TO: Kristopher Apanian, TAIT & Associates, Inc.
FROM: Amber Wood Hicken, Planner I
DATE: 4/10/25
SUBJECT: Parker Pointe, Auto Parts Store, Site Plan
Review Comments 01

PROJECT:
NEW O'REILLY AUTO PARTS STORE
STROH RD
PARKER, CO #2

Project Number: SP25-025

Description: Parker Pointe F1 L1 - Auto Parts Store

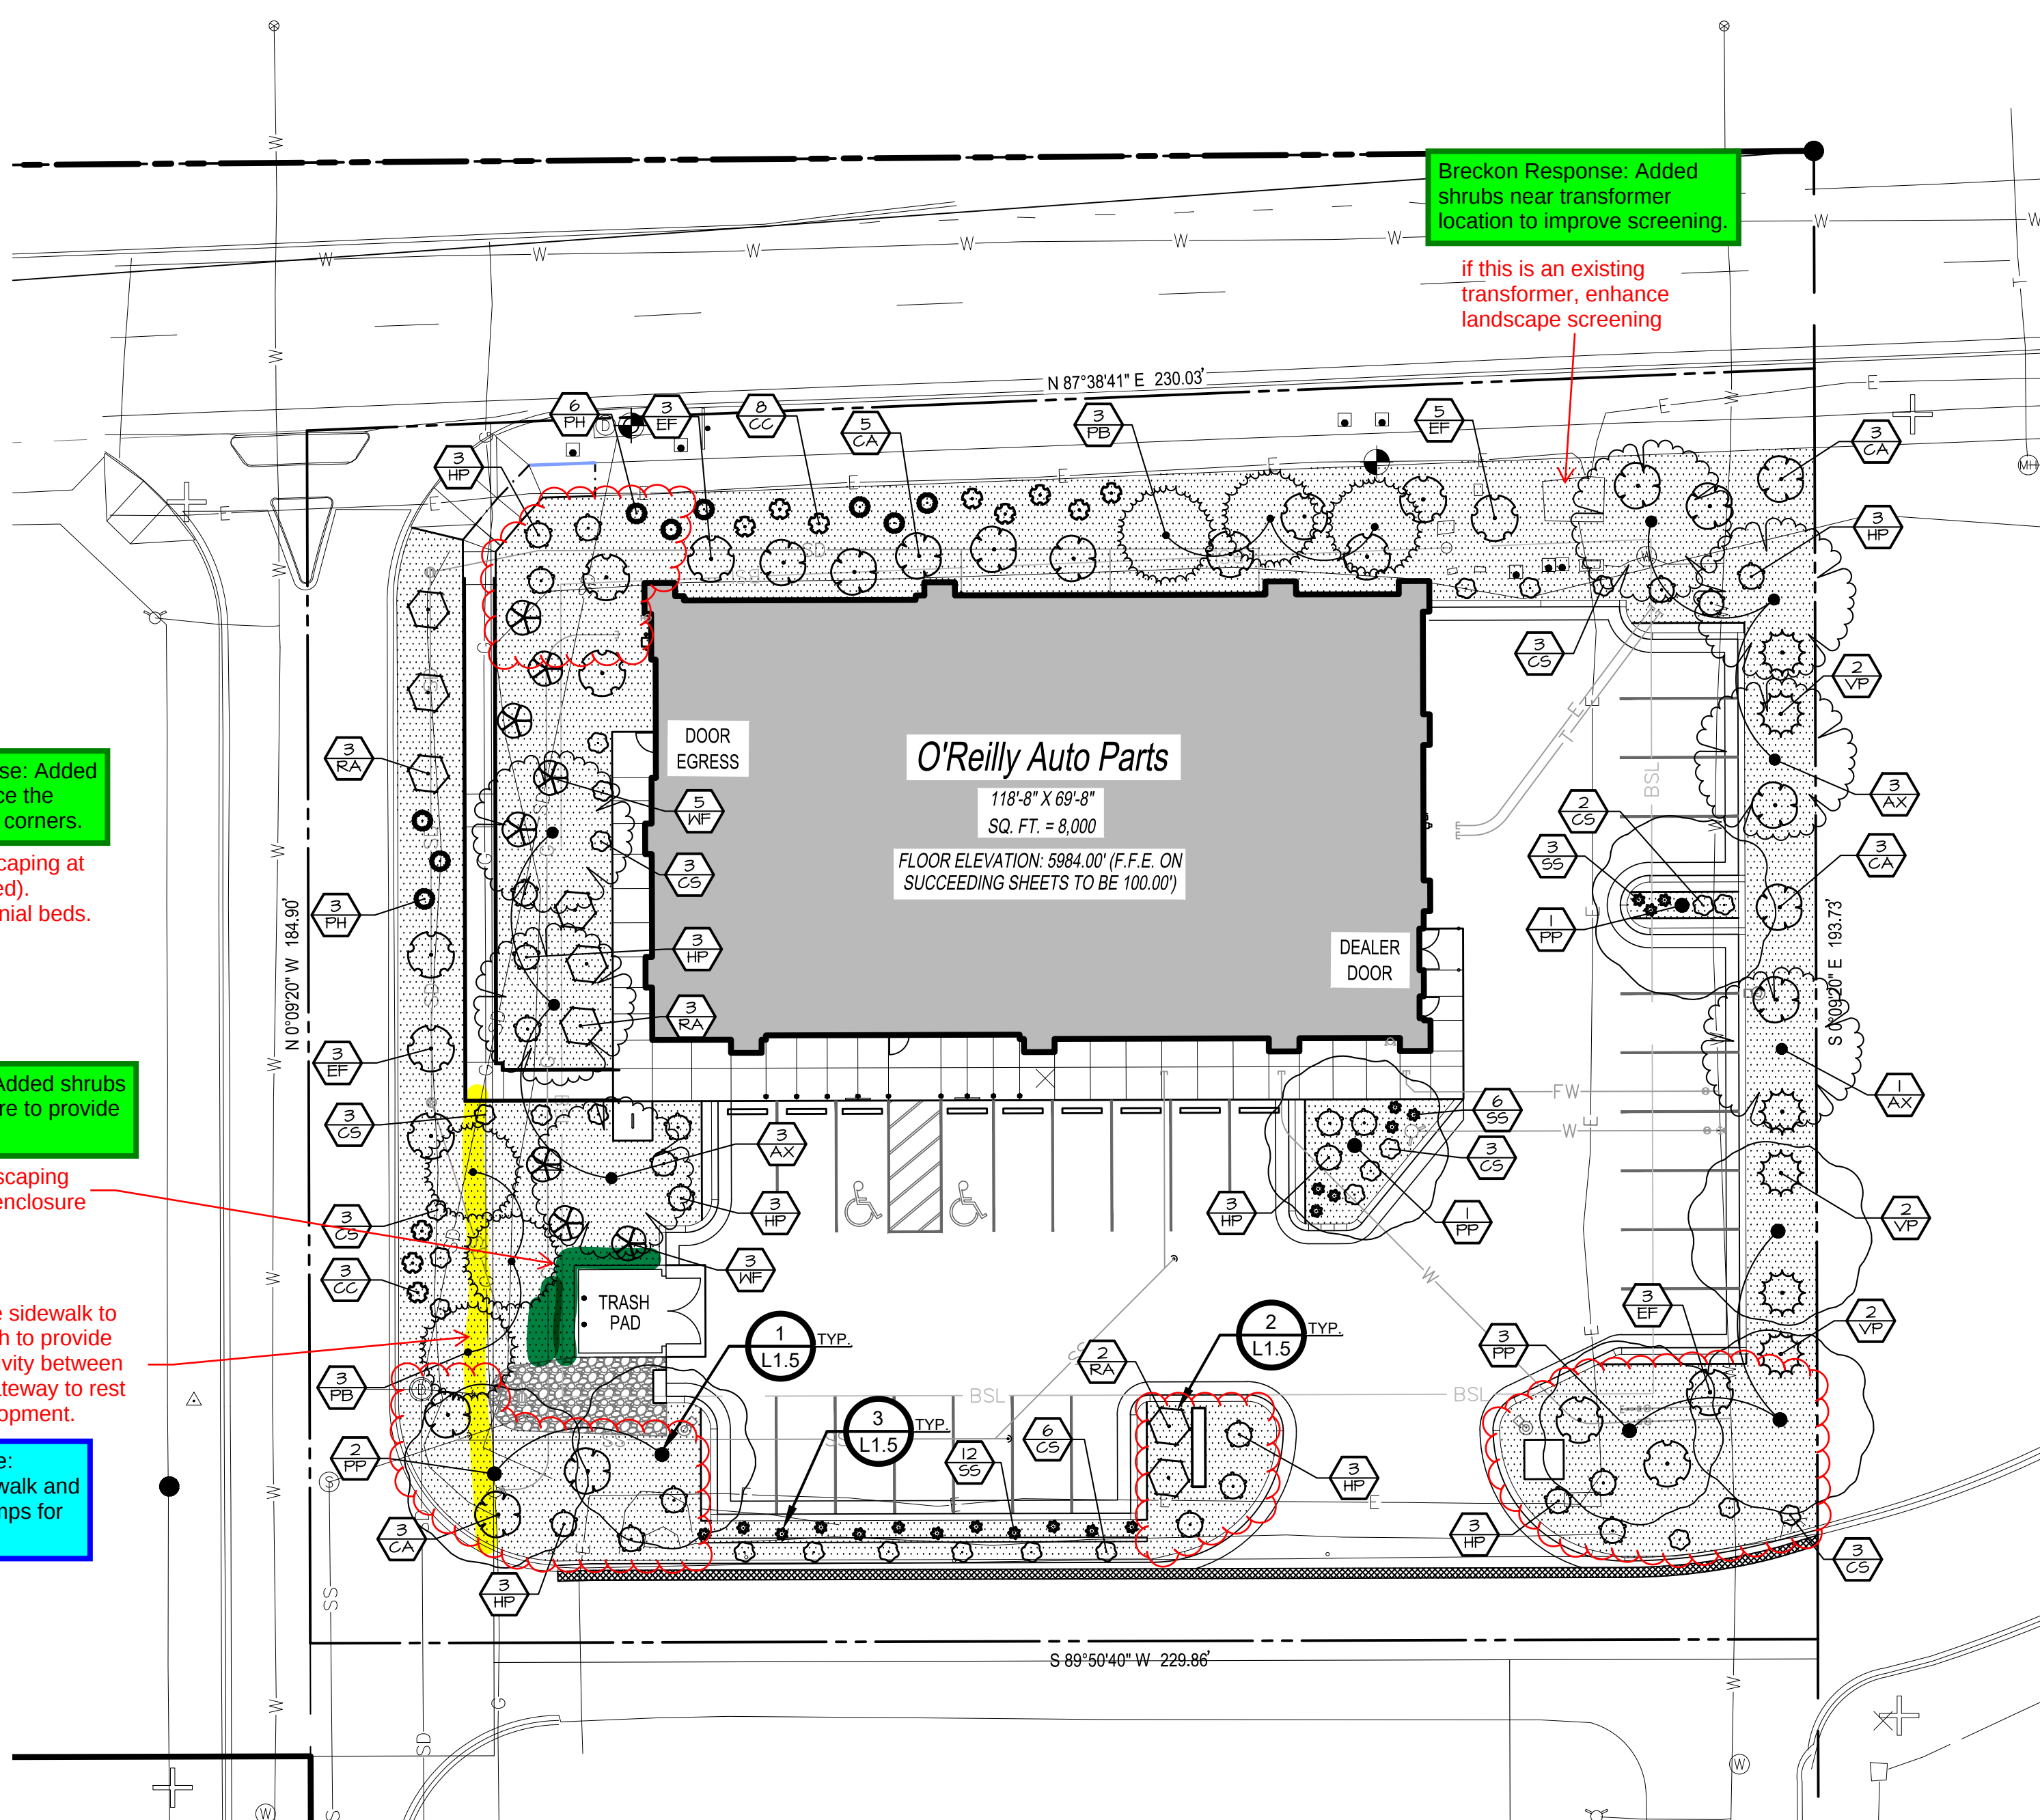
enhance landscaping around trash enclosure

continue sidewalk to the south to provide connectivity between sites, gateway to rest of development.

if this is an existing transformer, enhance landscape screening

Breckon Response: Added shrubs to enhance the landscape at the corners.

Breckon Response: Added shrubs around trash enclosure to provide more screening.

TAIT Response: Extended sidewalk and added curb ramps for connectivity

Breckon Response: Added shrubs near transformer location to improve screening.

LANDSCAPE REQUIREMENTS

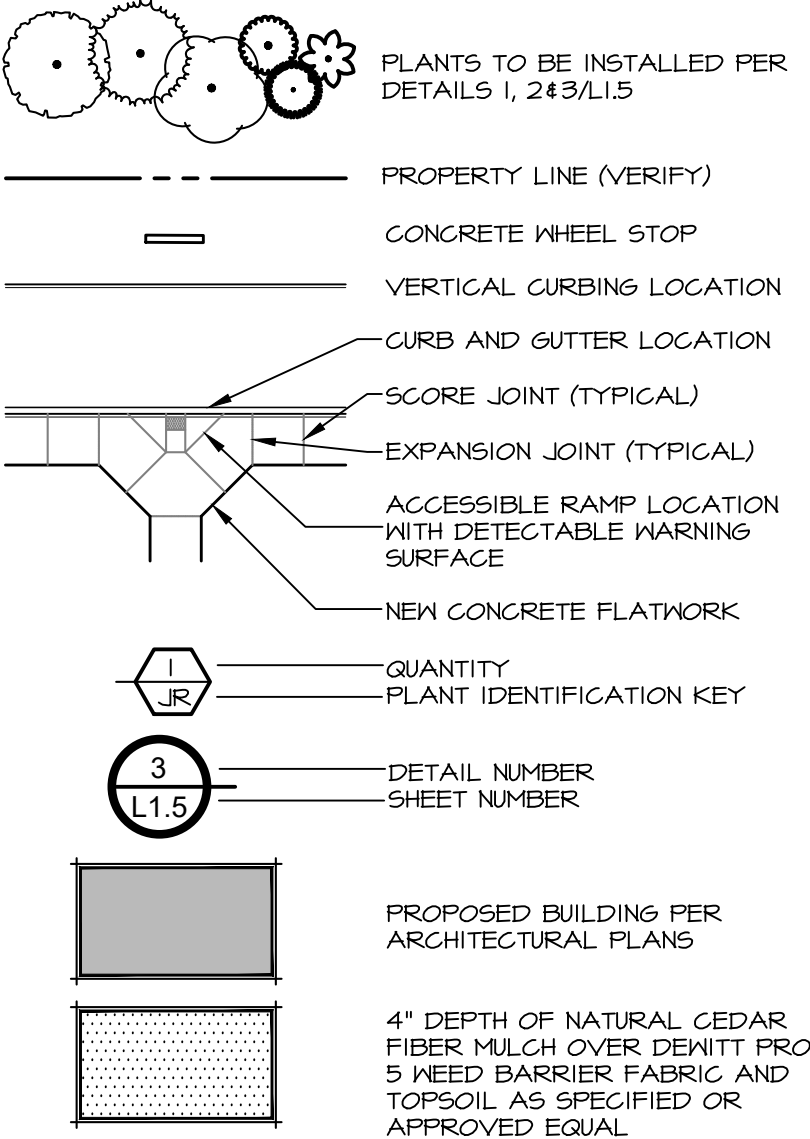
break out islands, show square footage & planting requirements for each

break out each property line. P1 landscaping applies to north, east, west, & a portion of south. P2 applies to portion of south property line with parking

show that requirements are met:

1 tree, 5 shrubs per 1,500sf of lot area not covered by building or required parking

15% of developed area must be landscaped (show percentage & square footage)

75% of required landscaping must be live cover (show percentage & square footage)

Breckon Response: Reorganized the landscape requirements tables to be clearer.

1 DECIDUOUS TREE BOX PLANTING

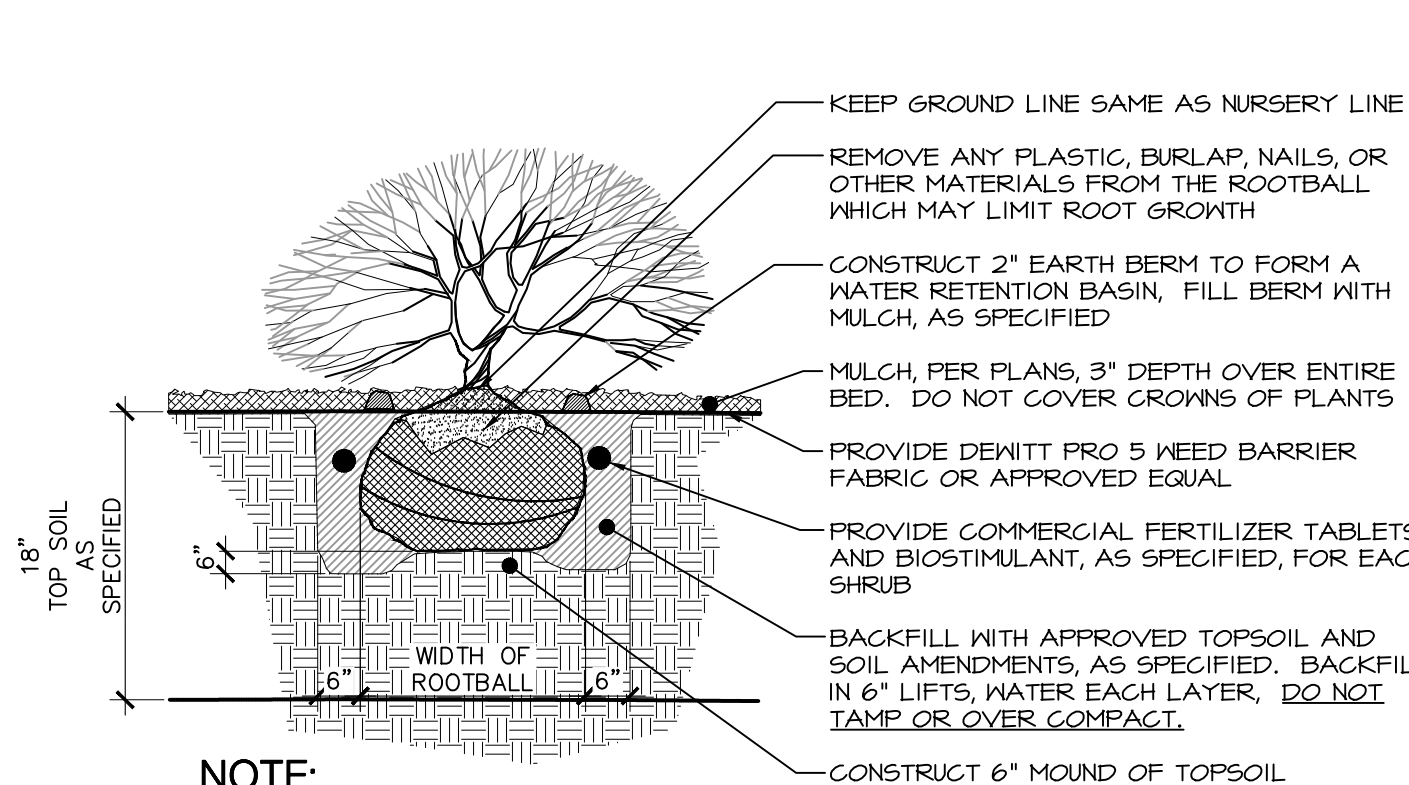
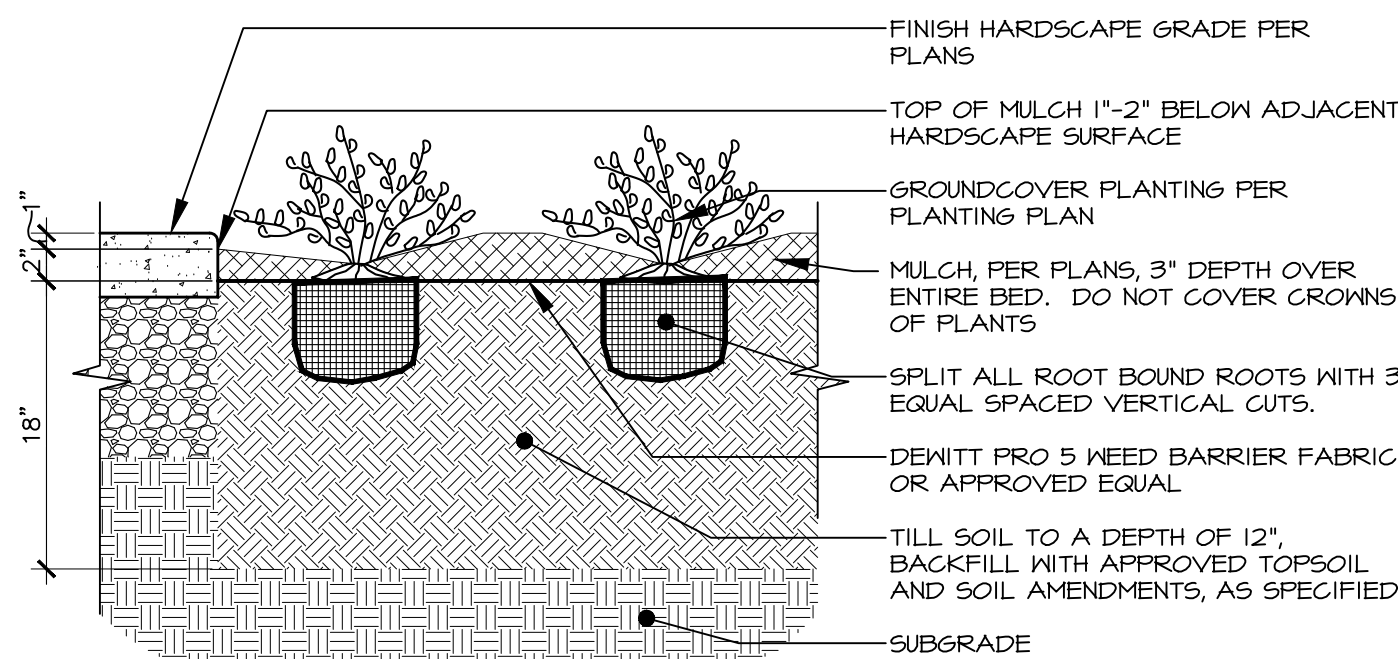
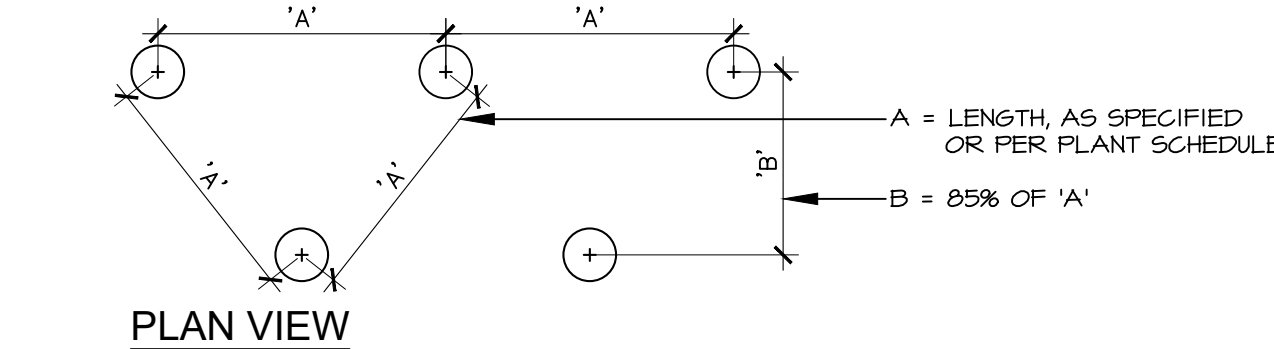
use town of parker planting standards

Breckon Response: Added further description on the details to match the city standard details.
